# Service Technical Information

MODEL NO. CSD-A310 / TD31 / TD32 / TD33 / TD41 / TD42 CA-DW237 / DW247 / DW257 / DW537
SUBJECT Frictional noise is produced when the CD lid is closed

REF.No. :G - A0 - 041 - E0

Fig-1

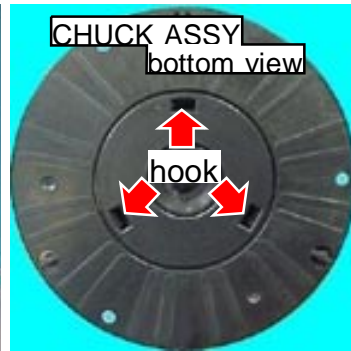
1. Remove the chuck part from the CD lid.  
(Remove from the rear side as shown in Fig-1.)
2. Release the hooks at three locations, and then remove the HLDR CHUCK.  
(See Fig-2 and 3)
3. Mount the new HLDR CHUCK ASSY (replacement part).  
Make sure that the hooks at all three locations are engaged.
4. Mount the chuck part to the CD lid.
